DATE: 07.25.2018
TO: ProTrak
FROM: Mitesh Baxi
Traffic Engineering

■ **ST MARK MAYFAIRE ENTRANCE [TRC Plan Review]**

↻ Initial Review Note ↻

OVERALL SITE PLAN
ST. MARK CATHOLIC CHURCH &
MAYFAIRE II ENTRANCE
EASTWOOD ROAD

St Mark Mayfaire Entrance Standard Street Lighting Plan

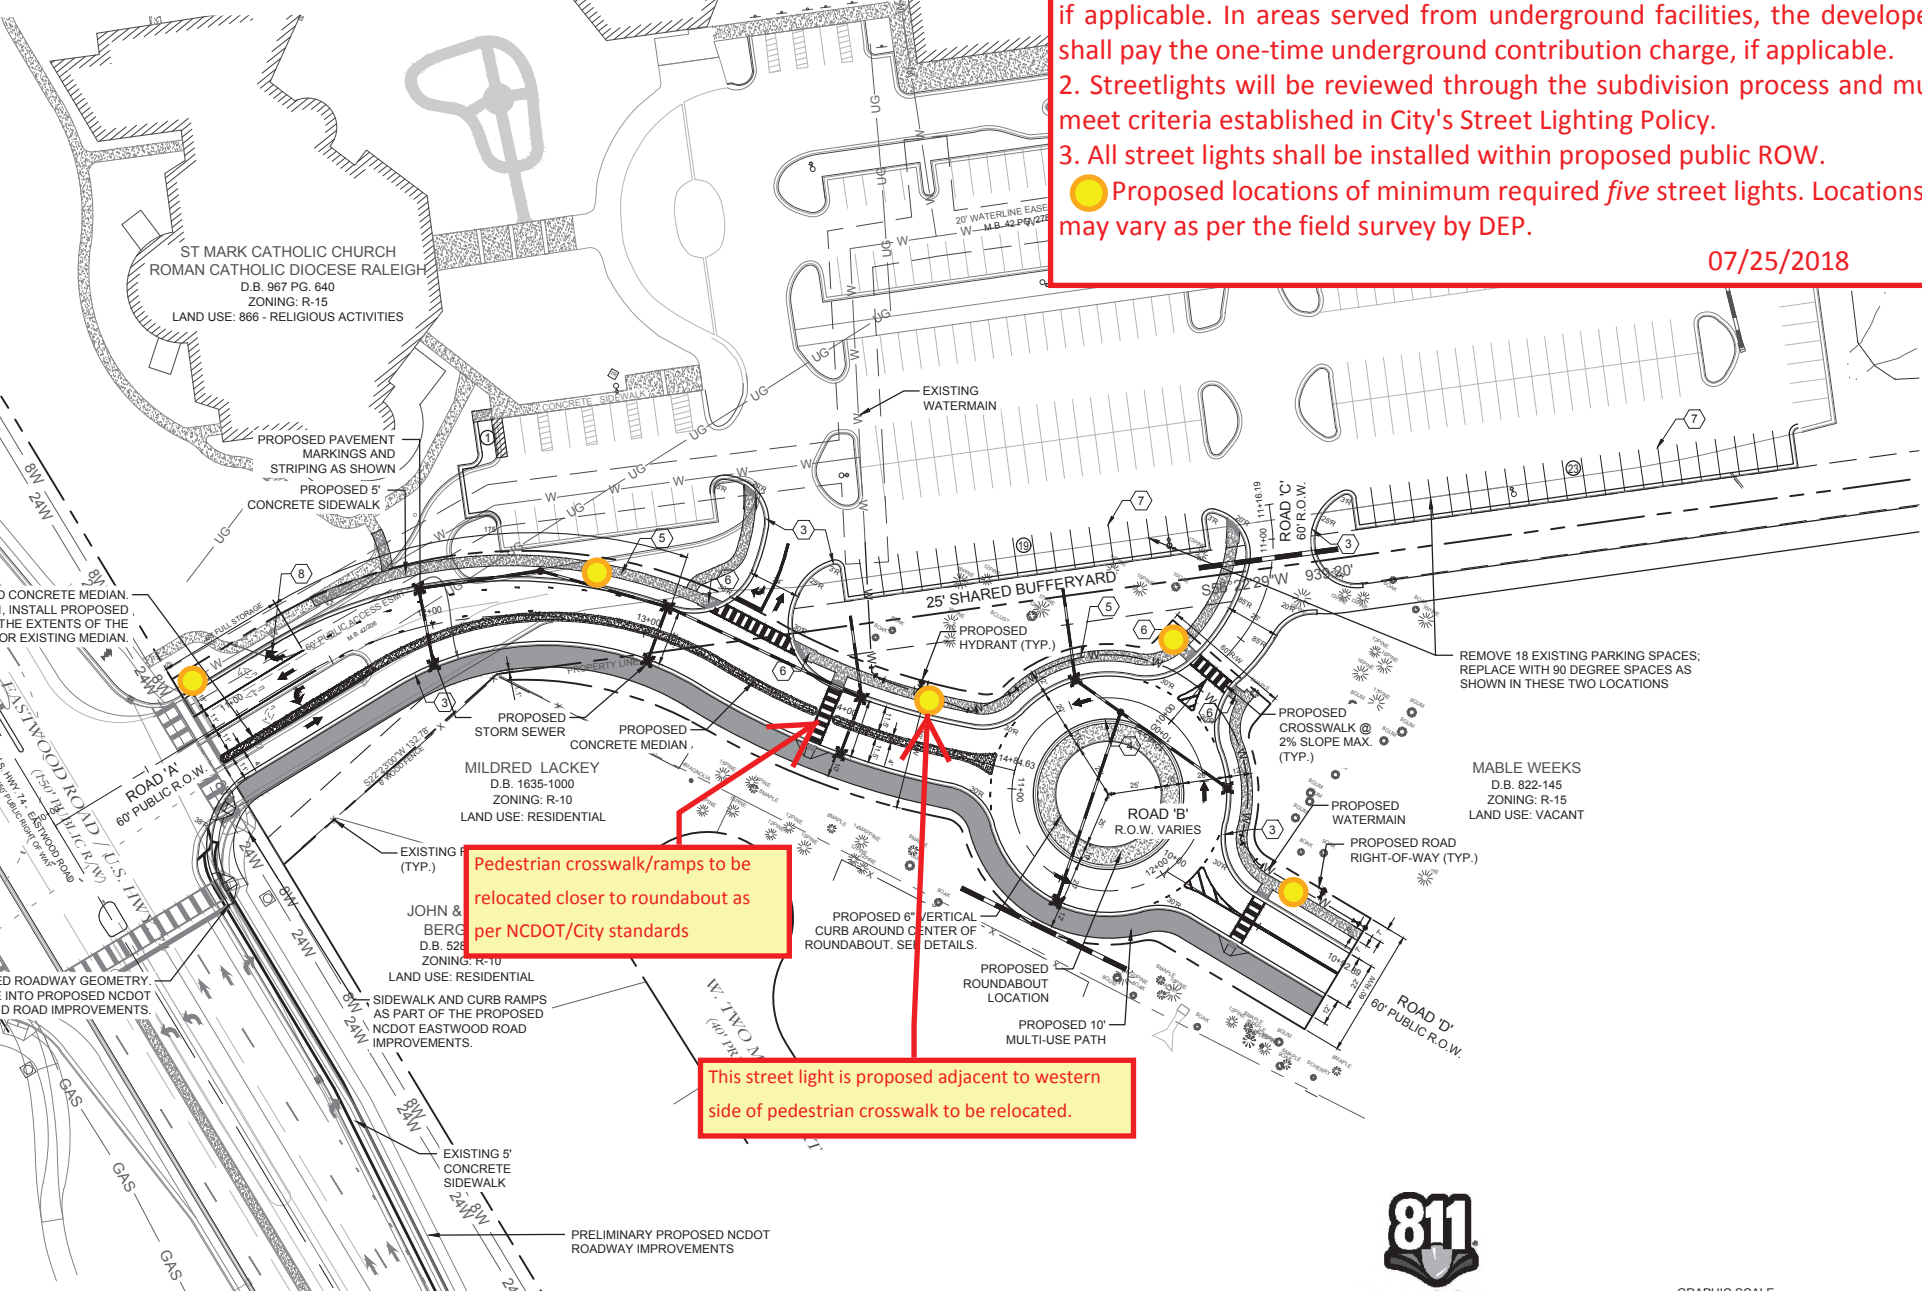
13. A layout for the Standard street lighting has been provided with the review. Minimum of 5 (Five) street lights are required for this sub-division. Although, developers may choose to provide any extra lights or ornamental. Any installations above the criteria of Standard street lighting, will be considered as non-standard and has to conform to the City's non-standard street lighting procedure as per the policy.

● Proposed locations of minimum required five street lights. Locations may vary as per the field survey by DEP.

MUST APPROVE OF PAVEMENT MARKING LAYOUT PRIOR TO ACTUAL STRIPING.

Pedestrian crosswalk/ramps to be relocated closer to roundabout as per NCDOT/City standards

This street light is proposed adjacent to western side of pedestrian crosswalk to be relocated.
